Ceived by OCD: 10/20/2025 8:44:28 Phone: (505) 476-3441	AM State of New Mexico	Form C-103 ¹ of
General Information Phone: (505) 629-6116	Energy, Minerals and Natural Resource	S Revised July 18, 2013 WELL API NO.
Online Phone Directory Visit: https://www.emnrd.nm.gov/ocd/contact-us/	OIL CONSERVATION DIVISION 1220 South St. Francis Dr. Santa Fe, NM 87505	5. Indicate Type of Lease STATE FEE 6. State Oil & Gas Lease No.
(DO NOT USE THIS FORM FOR PROPOSA	ES AND REPORTS ON WELLS LS TO DRILL OR TO DEEPEN OR PLUG BACK TO A TION FOR PERMIT" (FORM C-101) FOR SUCH	7. Lease Name or Unit Agreement Name Resler Yates State
	as Well Other	8. Well Number #332

Plug and Abandon

Wellname:	Resler Yates State #33	2		
Location:	2310' FSL & 2310' FEL;Sec J- NM	29-18S-28E; Eddy Co,		
Date:	August 7, 2025			
API#:	30-015-02109	Surf Csg Set:	7" 20# J-55	
Csg Size:	4 1/2" 9.5# J-55	Set @:	513'	
Set @:	2023'	Inter #1:		
Perfs:	1995'-2000' (20 shots)	Set @:

Action 517914

RESLER YATES STATE #332- Before WBS

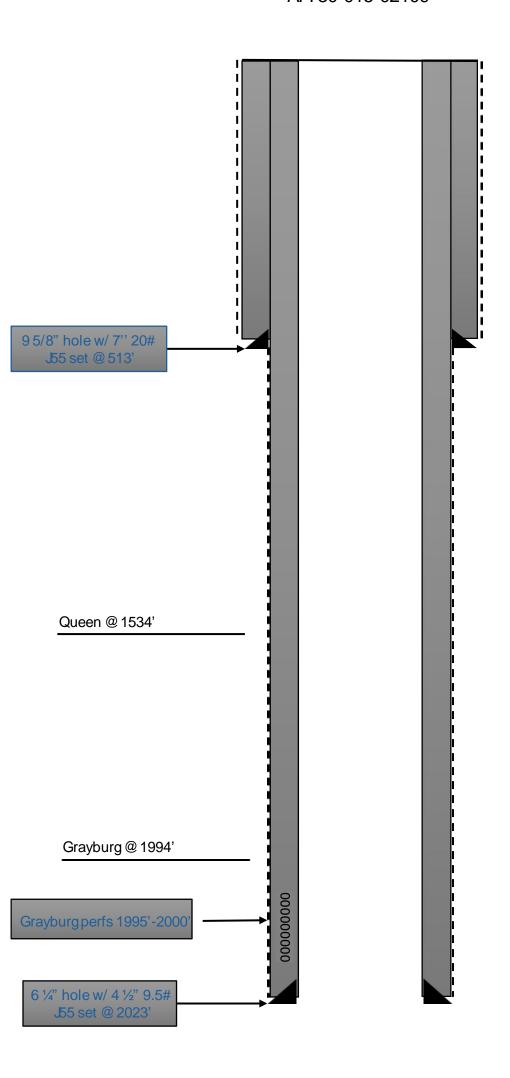
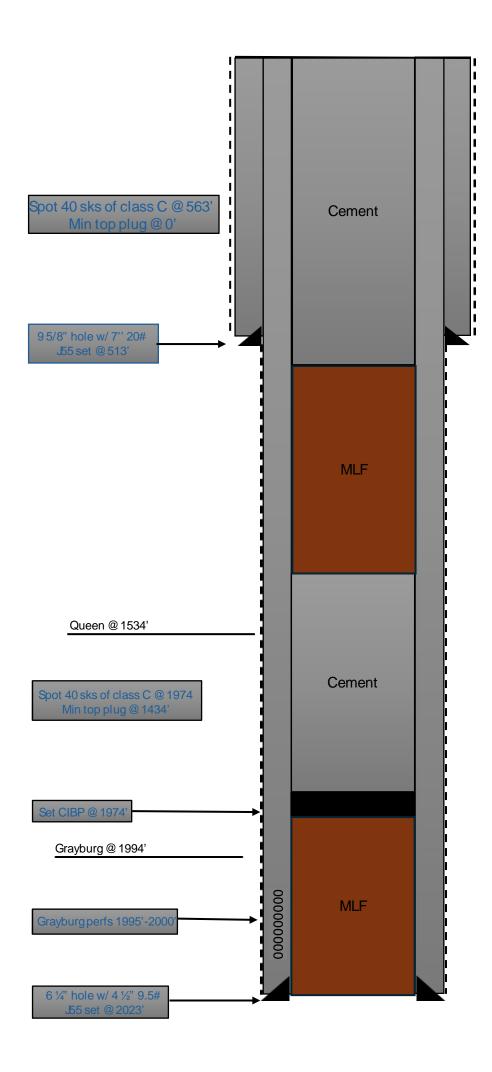
Created By	Condition	Condition Date
loren.diede	Notify the OCD inspection supervisor via email 24 hours prior to beginning Plug & Abandon (P&A) operations.	10/23/2025
loren.diede	NMOCD does not consider this well to be within the LPCH restricted area and an above ground P&A marker is required. NMOCD requires that plug (s) be added to cover the 7 Rivers = (930') and Yates = (600') formation tops. Submit photo and GPS coordinates of the P&A marker with the final P&A reports. The API# on the marker is to be clearly legible. Run CBL from CIBP to surface. Submit the CBL tif file to NMOCD for uploading into the Well Log File.	10/23/2025
